# Historic District Review Board

**May 21, 2013**
**4:30 P.M.**

**Item:** 5D – 621 Jefferson Avenue – Modifications to roofline, window, rear door and porch restoration.

# APPLICATION FOR HISTORIC DISTRICT REVIEW

FIGURE 1

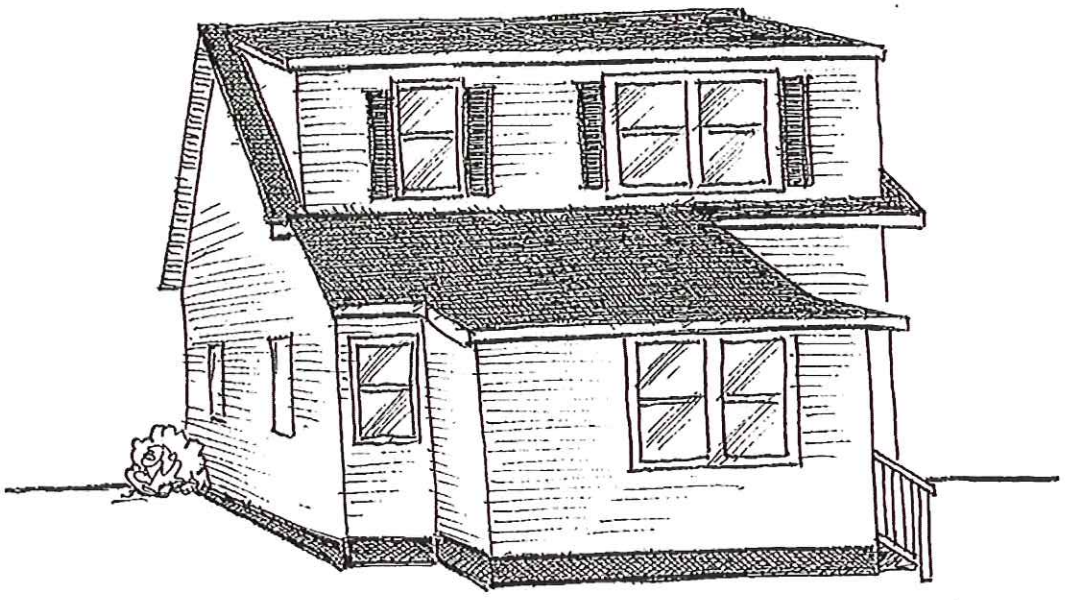
1. Extend second story rear dormer 60 inches on each side. The sides of the proposed new dormer will be on the same plane as the side of main part of the house. The roof of proposed dormer extensions will be in line with the existing dormer roof (same pitch and lines). The small ½ window on the left side of the dormer will be replaced with a larger window similar in size and style to the pair of windows on the right side on the dormer. See FIGURE 1.

FIGURE 3

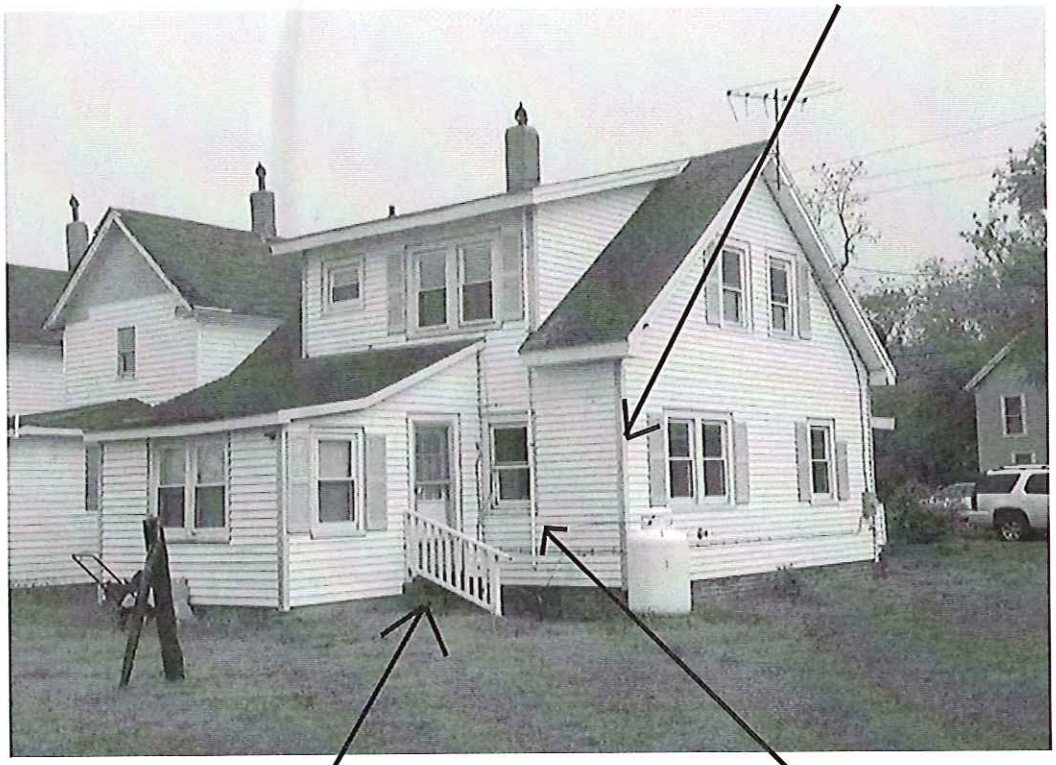
5. Replace existing rear window with new 6 foot vinyl siding glass door on rear of house. Construct small 8ft x 6ft deck on rear of house adjacent to new sliding door. Deck will be a wooden structure with grey composite decking and white vinyl rails. Deck will not extend past the side of the house. Deck will be approximately 26 inches from ground. See FIGURE 3.

Deck will not extend past this corner.

This railing and stair set will be removed. New deck will be accessed from new sliding glass door and existing door. New deck will have stairs leading to the rear of the property

Replace this window with 6 ft sliding glass door.
